2000 Annual Inspection Waste and Water Management Facilities Vangorda Mine Yukon Territory

February, 2001

1CD003.03

FIGURE 6: PIEZOMETER LEVELS - VANGORDA WASTE DUMP

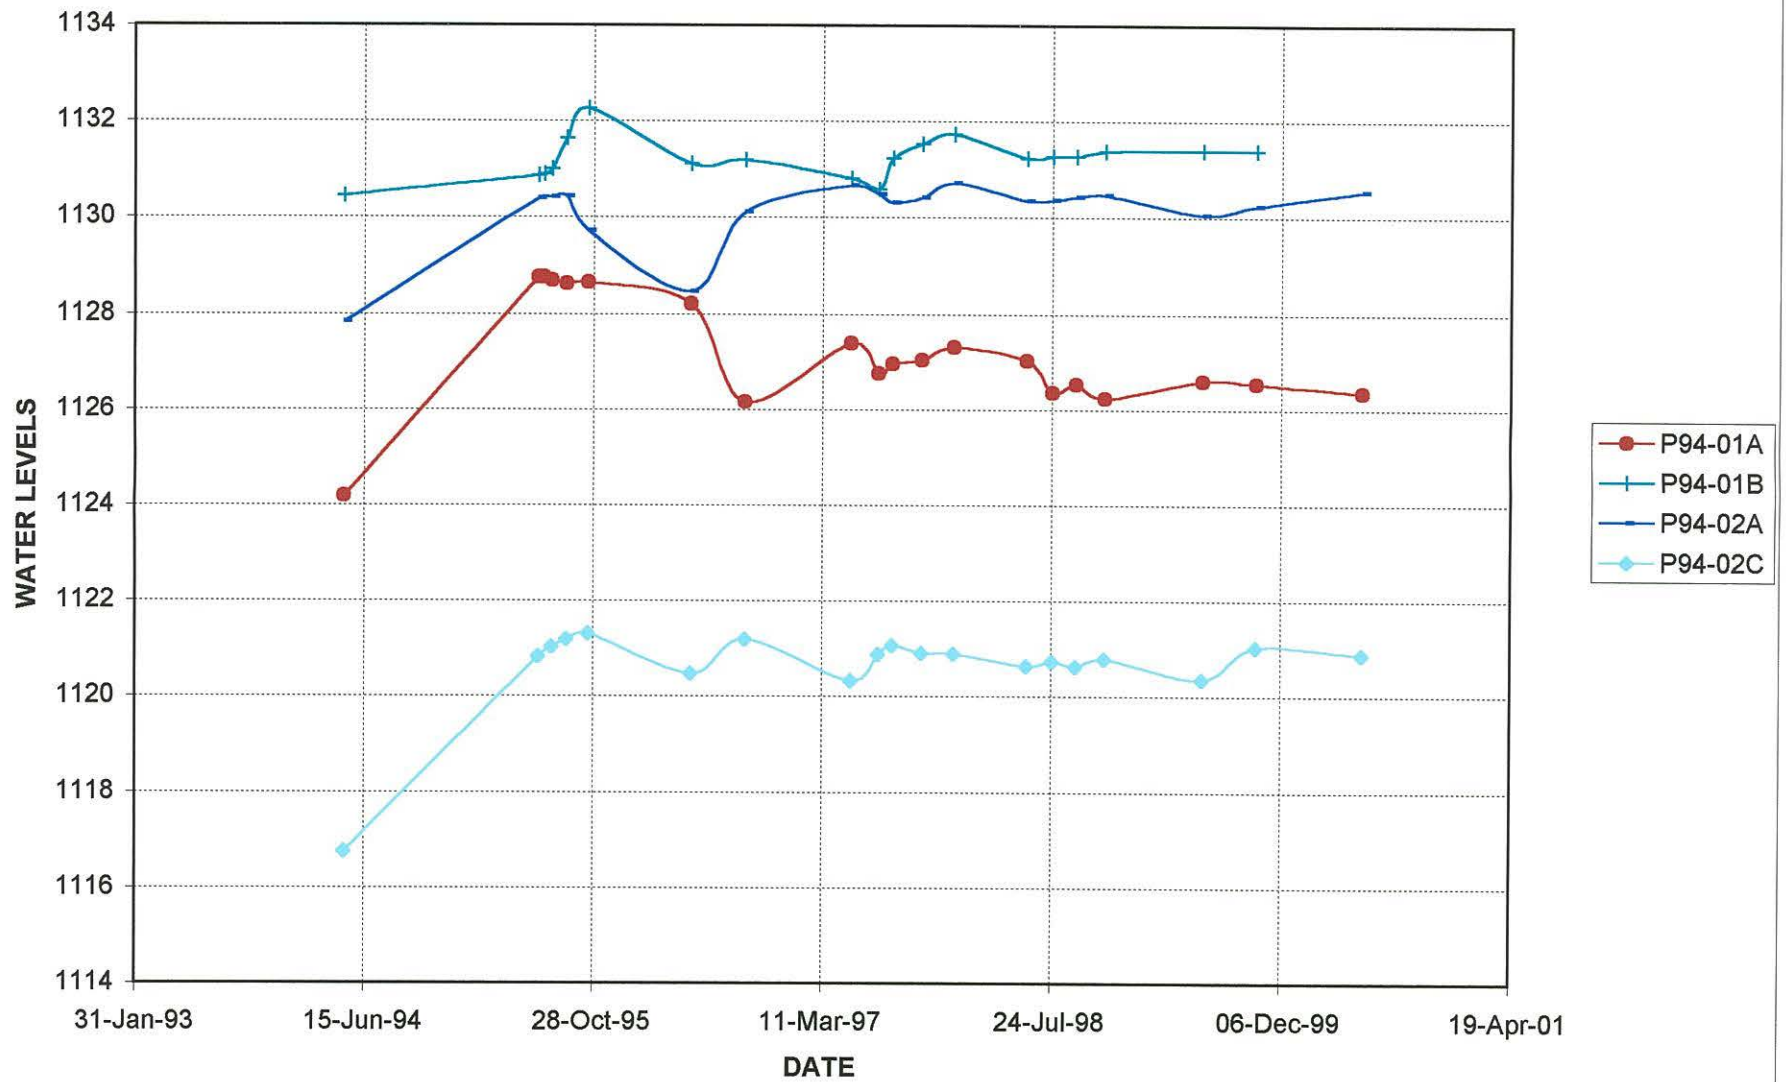
DT has been taking water level readings from the nine piezometers and four of the five groundwater wells around and within the facility. A summary of the water level readings taken to date in both the piezometers and the groundwater wells is presented in Table 1. Water levels, as recorded on May 31, 2000 in Piezometers P94-01A, 01B, 02A and 02B, are shown in Figures 4 and 5. A plot of the historical readings for these piezometers is shown on Figure 6. The water levels in the piezometers continue to remain generally static with minor fluctuations. Figure 7 presents a plot of the levels in the groundwater wells around the dump.

Water level readings should continue to be taken from both the groundwater wells and the standpipe piezometers in the till berm around the rock pile. These readings should be taken at least semi-annually with close attention given to the water levels in P94-01A and B, and P94-02A, 02B and 02C.

VANGORDA PLATEAU MINE	
		LITTLE CREEK DAM EMERGENCY SPILLWAY	
PROJECT NO.	DATE	APPROVED	FIGURE
1CD003.03	JAN. 2001		8

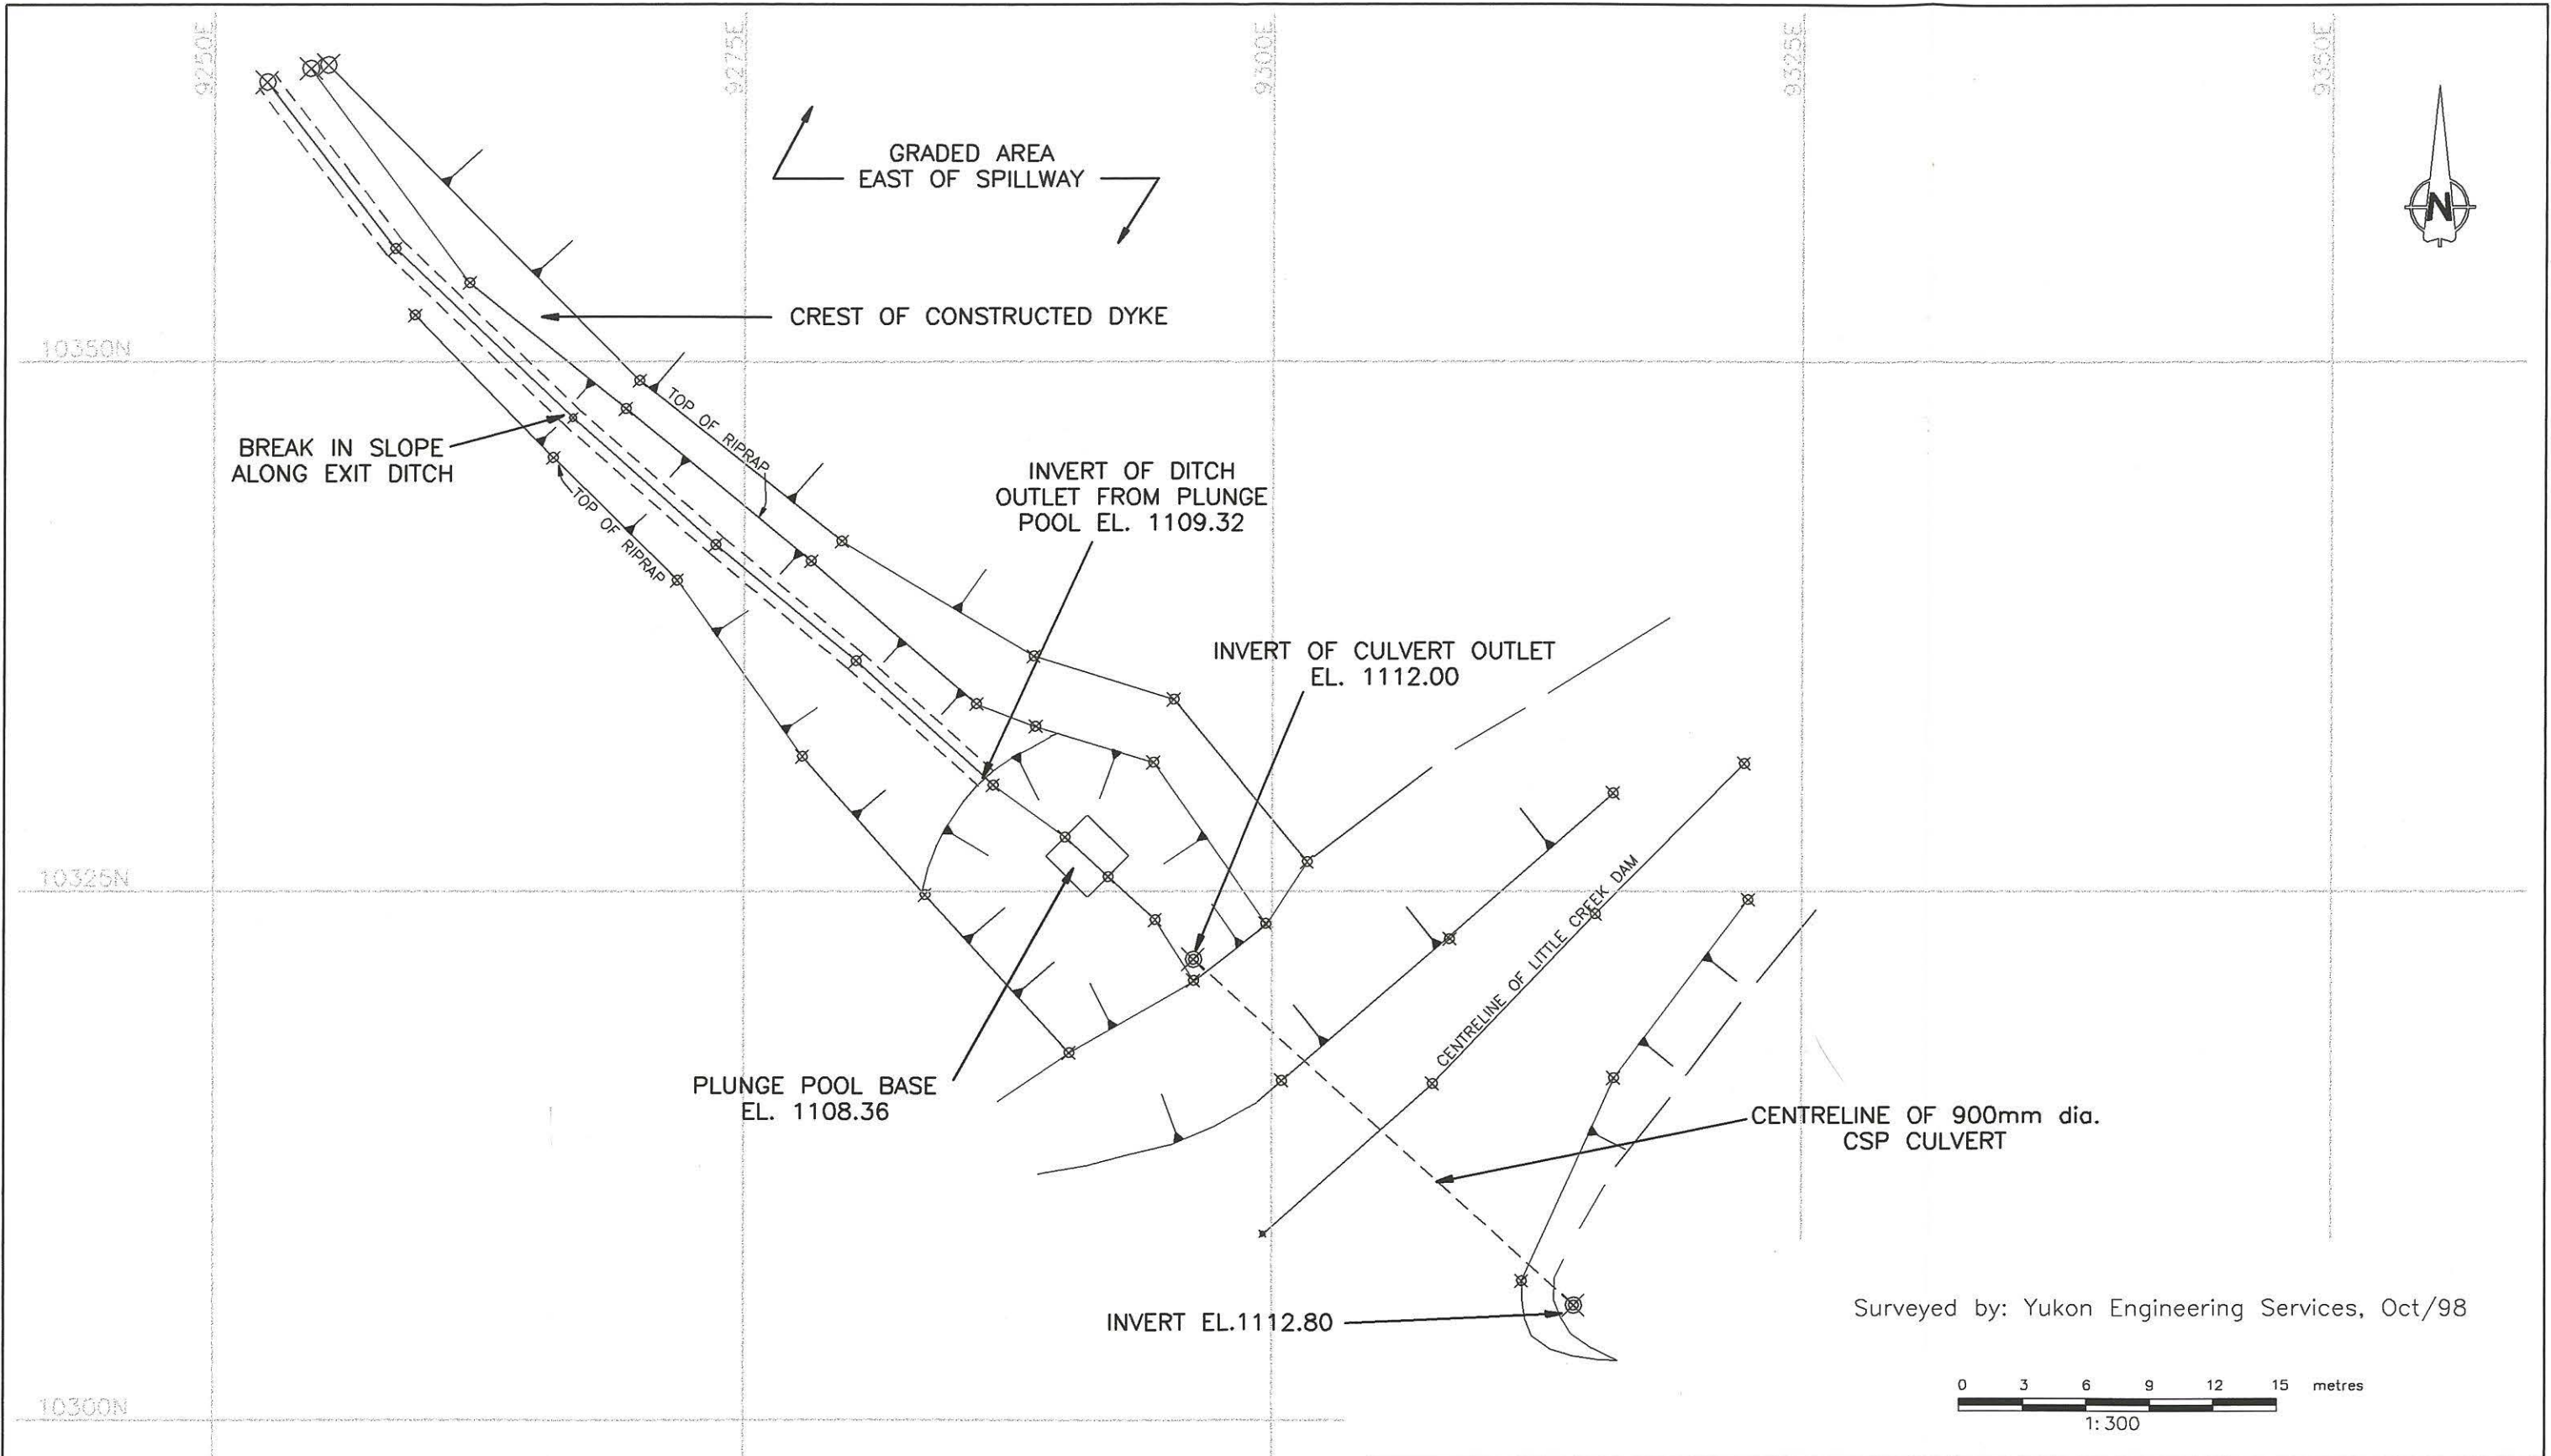
The new spillway culvert in Little Creek dam (photos 15 and 16 and Figure 8) was also inspected during the site visit. The additional riprap that was added in September of 1999 provided the needed erosion control at the entrance to the pipe.

The riprap in the plunge pool and the upper reaches of the exit chute meets design criteria. However, more riprap is required in the lower reaches of the exit chute to provide adequate erosion protection for the 200-year flood event (Photo 17).

**LITTLE CREEK DAM
GENERAL ARRANGEMENT PLAN**

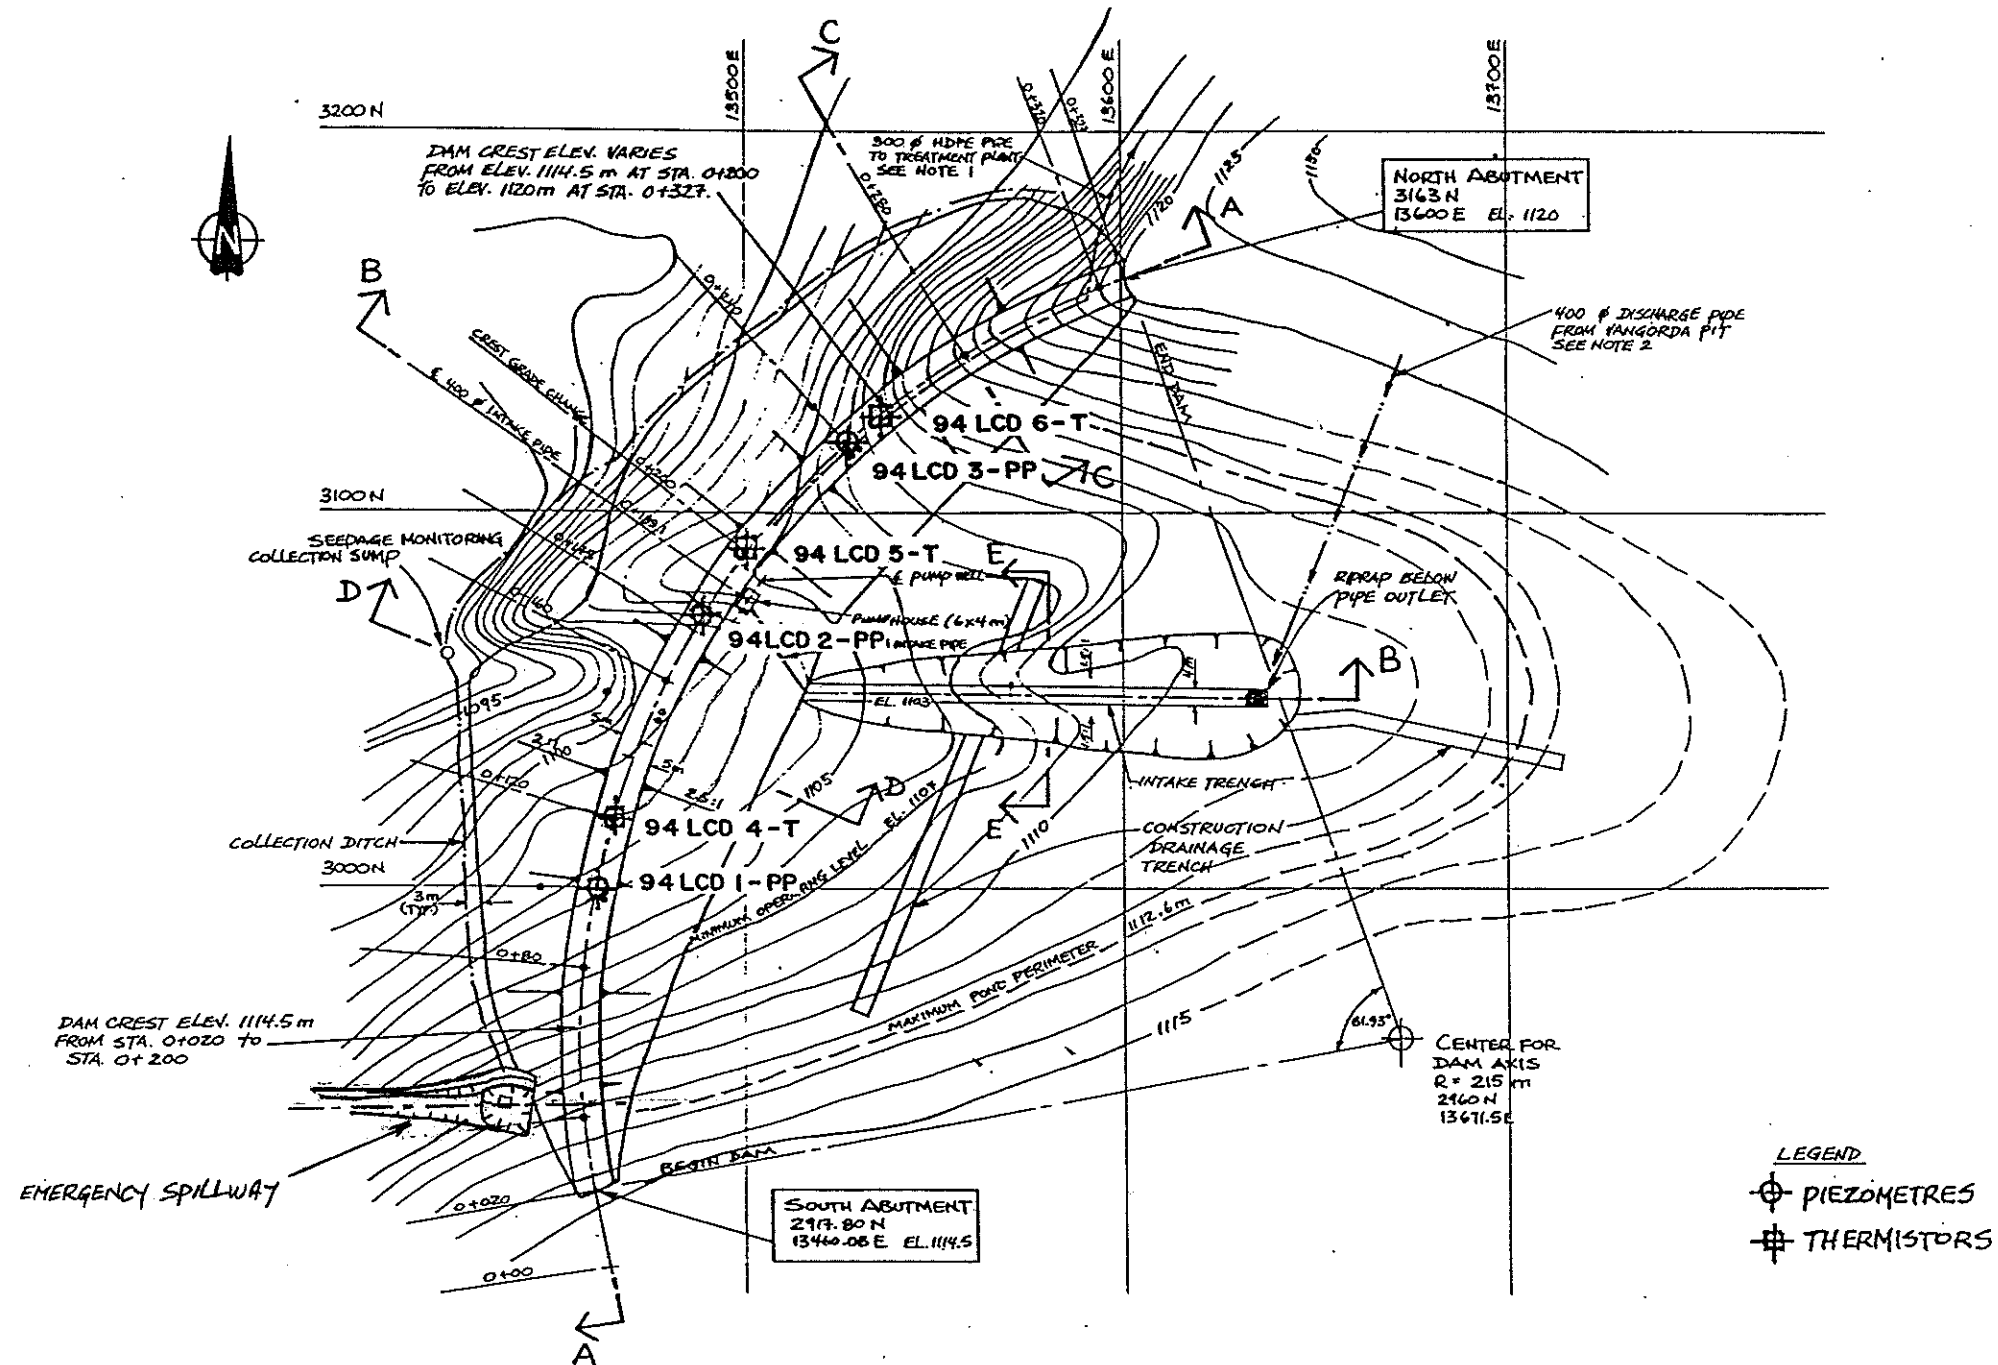
In 1994, six pneumatic piezometers and three thermistors were installed along the crest of the Little Creek dam. The six piezometers are located at three separate locations; two piezometers, one deep and one shallow, at each location. The location of the piezometers and thermistors are shown on Figure 9 and the most recent 2000 piezometric levels are shown in section on Figures 10 to 12. Actual readings are presented in Appendix B.

The piezometric levels are consistent with the water levels recorded in the impoundment and are in accordance with the design safety factors associated with the stability of the dam. The thermistor readings are also consistent.

SRK recommends that the pneumatic piezometers and thermistors are monitored on a semi-annual basis and the results compiled and forwarded to SRK.
